HAP 17-023-L
L. E. Dent

TO:	CHAIR AND MEMBERS LONDON ADVISORY COMMITTEE ON HERITAGE MEETING ON WEDNESDAY MAY 10, 2017
FROM:	JOHN M. FLEMING MANAGING DIRECTOR, PLANNING AND CITY PLANNER
SUBJECT:	HERITAGE ALTERATION PERMIT APPLICATION AT 882 LORNE AVENUE, OLD EAST HERITAGE CONSERVATION DISTRICT BY: A. RODIE

APPENDIX C — Drawing for porch at 882 Lorne Avenue

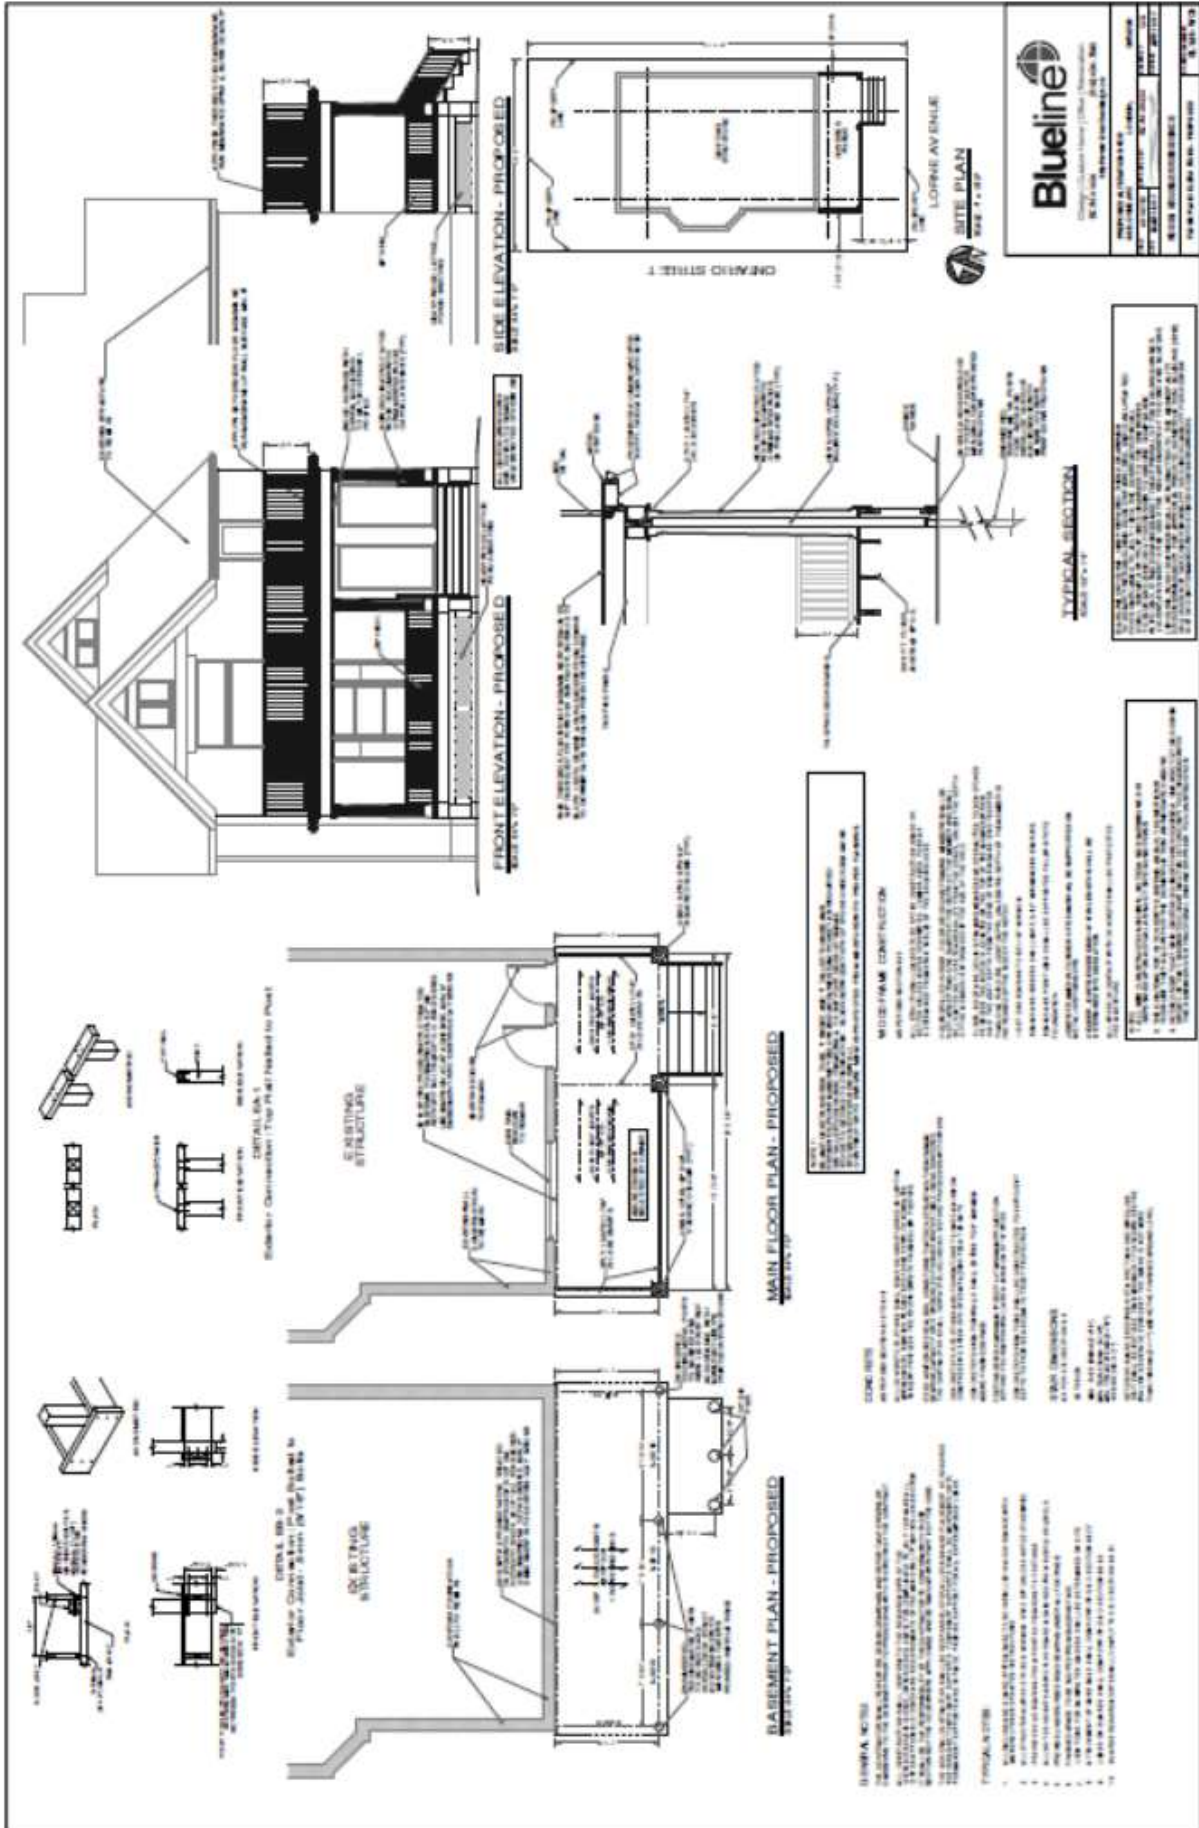
- Installation of (3) round porch columns, fluted shafts, fabricated of wood; ornamented column capital made of wood (or fiberglass material if wood is cost prohibitive); note discrepancy with drawing
- Columns' full height to be supported beneath deck by engineered metal posts

- The property owner forgo pursuing decorative Ionic column capitals (either in wood or fiberglass) and install instead wood turned columns that have a Tuscan capital which is fully integral with the column shafts; these columns should not be fluted which is typical for this Classical Order as well as being a standard available through column fabricators [Appendix F].
- This solution will also avoid the potential difficulty of matching and material transitioning the wooden column shaft to fiberglass column capitals. The recommended approach respects heritage principles of not over embellishing new details (*Conservation Plan*, Section 3.1).

- a) A total of five full capped newel posts (of wood) — (2) at corners of the upper deck with (1) in between positioned over the lower deck column, and (2) additional capped posts at bottom of run on either side of porch stair
- b) A total of two capped partial newel posts (of wood) located at existing brick face wall at upper deck
- c) Cornice eave and entablature profile and detailing constructed based on original porch
- d) Wood lattice skirting beneath porch stairs
- e) Smooth wood columns with integral Tuscan capitals made of wood
- f) All exposed wood to be primed and painted
- g) The Heritage Alteration Permit be displayed in a location visible from the street until the work is completed.

- a total of five capped full newel posts (of wood) — (2) at corners of the upper deck with (1) in between positioned over the lower deck column, and (2) additional capped posts at bottom of run on either side of porch stair [Appendix G]
- a total of two capped partial newel posts (of wood) located at existing brick face wall at upper deck [Appendix G]
- cornice eave and entablature profile and detailing constructed based on original porch [Appendix E]
- wood lattice skirting beneath porch stairs
